Product Discontinuation Notices

No. 2011010E

Discontinuation Notice of Beam checker Type E39-VX

Dimensions

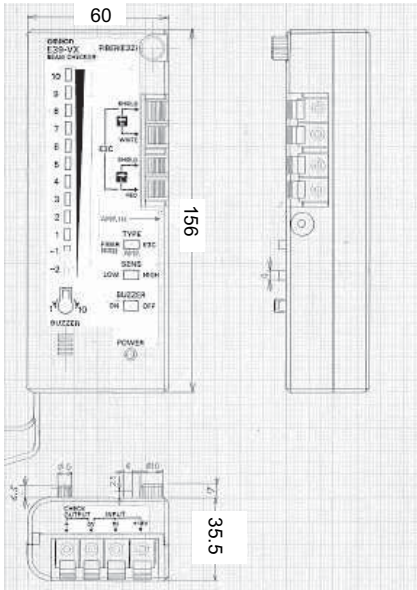
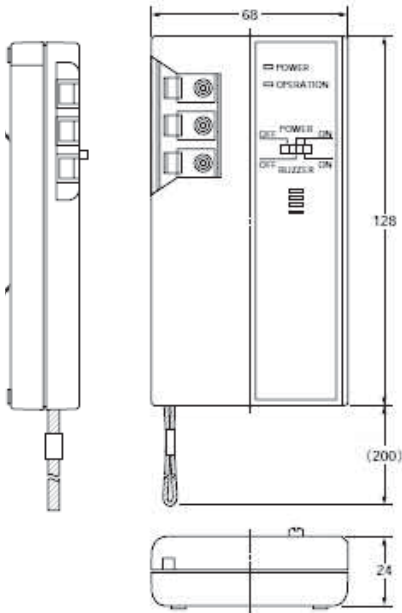
E39-VA is able not to connect them though E39-VX can connect the E32 fiber unit and the E3C amplifier separation sensor head. Therefore, an optical axis is matched and there are neither a function nor an analog output terminal.

Product discontinuation E39-VX	Recommendable replacement E39-VA
